From: Paul G. Shumejko, MBA, M.S., PTOE, P.E., Transportation Engineering Manager
To: Kristen Kapelanski, AICP, Planning Manager
Date: March 9, 2020
Re: Rochester Hills Research Park, City File #18-021, Sec 21
Planning Commission Traffic Questions

Based upon the Planning Commission meeting held on Tuesday, February 18, 2020, Engineering Services has further reviewed the proposed PUD plan, with input from the Road Commission for Oakland County (RCOC), for the above referenced project.

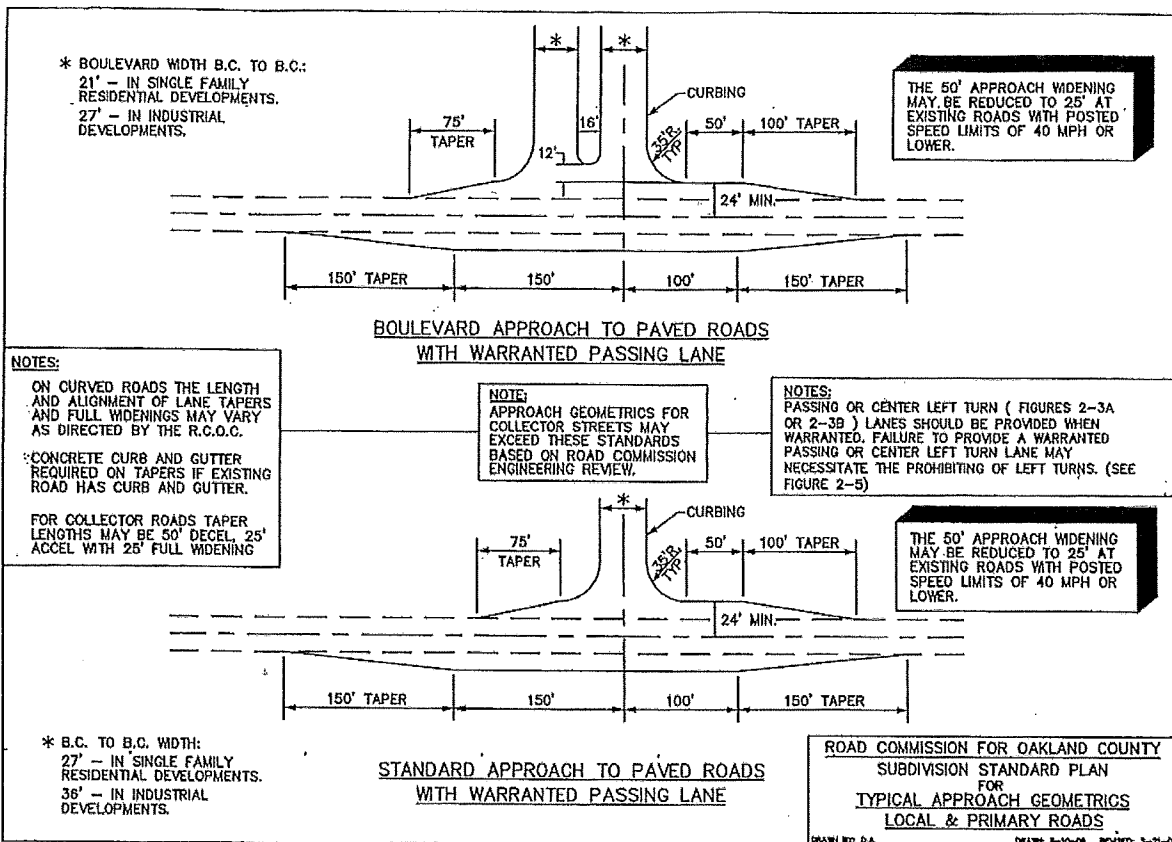
1. Based upon the data compiled within the Traffic Impact Study, a continuous center left turn lane (CLTL) across the property frontage was not warranted.

2. Had one been warranted, there are several geometric constraints that would make extending the existing CLTL very challenging as a standalone isolated project.

- a. Due to the required CLTL taper transition lengths (RCOC detail attached for reference), they would essentially overlap each other, thus requiring the CLTL to extend from its current point of beginning just south of Drexelgate Pkwy and continue north to Dressler Ln (~ 1,600 feet). The existing traffic signal at Livernois Rd and Horizon Ct would also need to be replaced and upgraded to a box-span design with full signal phasing.

- a. SB Livernois Rd just north of existing dental office.
 - i. Extend the full right-turn lane from the dental office and tie into dedicated right-turn lane at EEI Global's current main entrance. This will create one continuous right-turn lane and eliminate the existing "jog". ~\$25k

- b. WB Horizon Ct (future Horizon Dr).
 - i. Construct a dedicated right-turn lane exit to allow traffic to continue travelling without having to stack waiting for NB Livernois Rd traffic to exit. ~\$150k

1. Right-turn lane length - 150 feet
 2. Entering taper length - 100 feet
 - c. NB Livernois Rd at Horizon Ct (future Horizon Dr). ~\$175k
 - i. Improve the existing passing lanes to meet RCOC requirements.

1. Entering taper - 150 feet
 2. Passing lane length - 150 feet
 3. Thru lane portion - 100 feet
 4. Exiting taper - 150 feet
 5. They are currently 100 feet, 100 feet, 95 feet and 125 feet, respectively.
